SUBJECT: Additional Information - TMI Unit 1 25<sup>th</sup> Year Reactor Building  
Tendon Surveillance Report

Three Mile Island, Unit 1 (TMI Unit 1)  
Operating License No. DPR-50  
NRC Docket No. 50-289

**25<sup>TH</sup> YEAR REACTOR BUILDING  
TENDON SURVEILLANCE (PERIOD 7)**

Topical Report No. 136  
Revision 01

Figure 1  
Vertical Tendon Force Trend

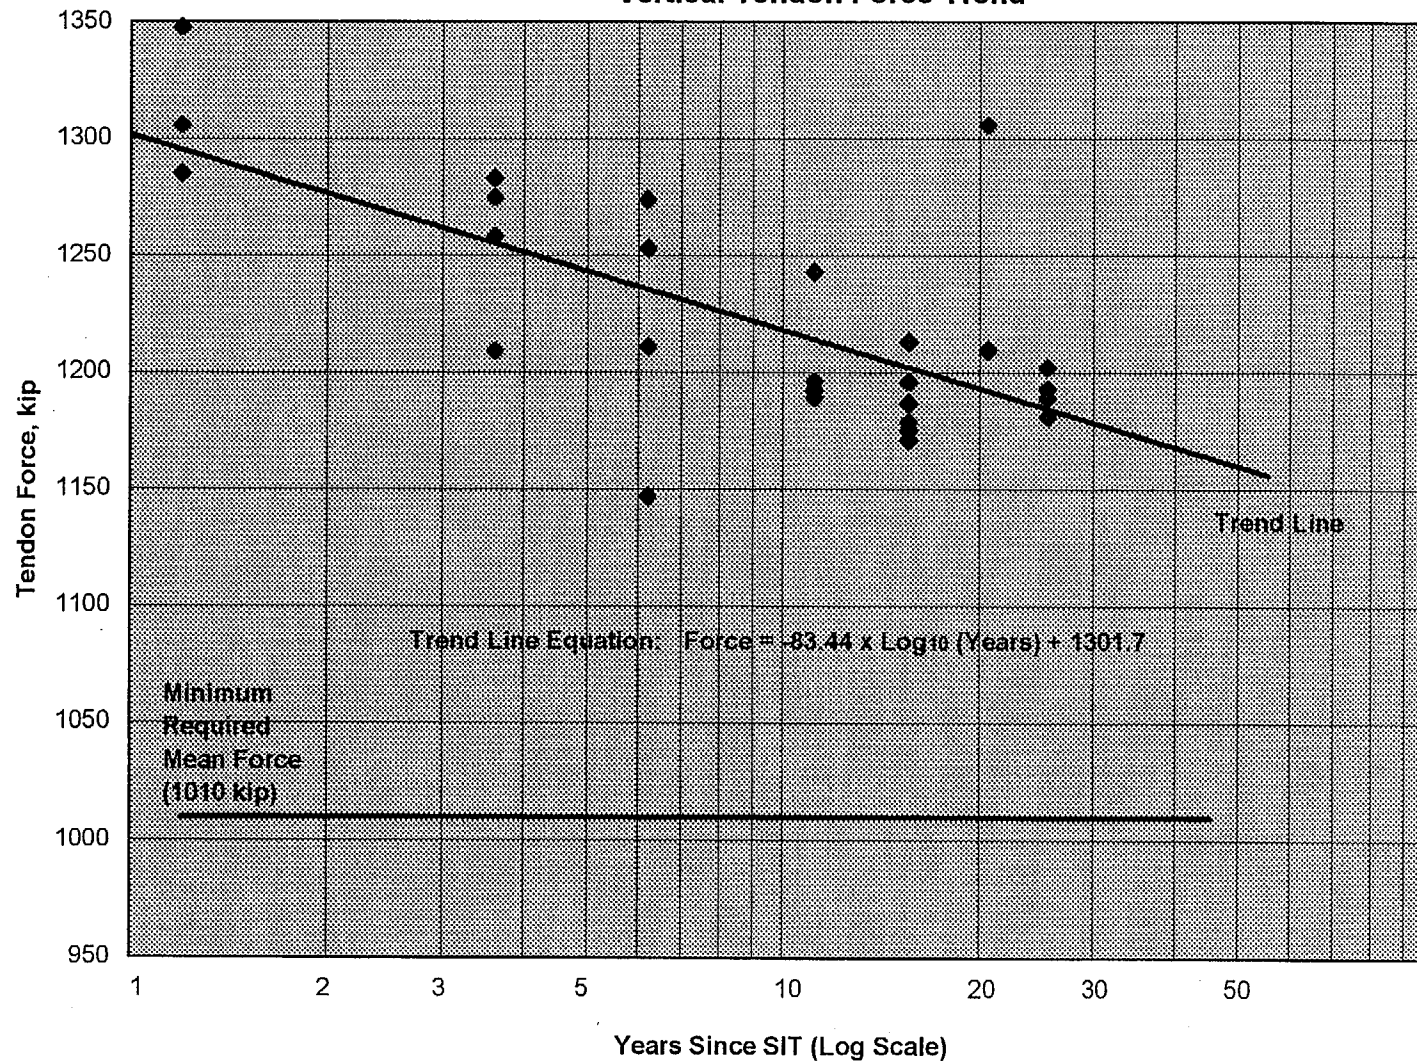
In a conference call on March 7, 2001, the NRC questioned the approach of applying normalizing forces to the individual as found tendon lift-off forces when plotting the vertical, hoop, and dome tendon forces vs. time trend plots in Attachment 1 to the TR. In response to the NRC's request enclosed is TR No. 136, Revision 1, in which the normalizing forces have been removed. The conclusions of the report are unchanged.

Figures 1, 2 & 3 are, respectively, plots of vertical, hoop and dome tendon forces vs. the log of time since the Structural Integrity Test (SIT). The SIT date is selected as the starting point for time since both Regulatory Guide 1.35 and Subsection IWL use this date as the basis for scheduling post-tensioning system in-service inspections. The logarithmic scale is used for the horizontal axis since time dependent losses (concrete creep, concrete shrinkage and tendon stress relaxation) are generally postulated to follow exponential relationships. Therefore, tendon force is expected to decrease in a relatively linear fashion with the log of time (but, in fact, does not as discussed below). The numerical data used to construct the plots is that listed in Tables 7, 8 & 9. The plotted forces are not normalized.

Figures 1 & 3 show that all vertical and dome tendon forces measured to date are well above the minimum required mean forces specified in FSAR Par. 5.7.5.2.3.f (Update 15). In addition, the trend lines remain well above the applicable minima for many decades after the current TMI-1 operating license expires. It can, therefore, be concluded that the mean levels of force in the vertical and dome tendon groups will not fall below the respective minima prior to the next surveillance or, in fact, prior to any surveillance performed during the period of validity of the current operating license.
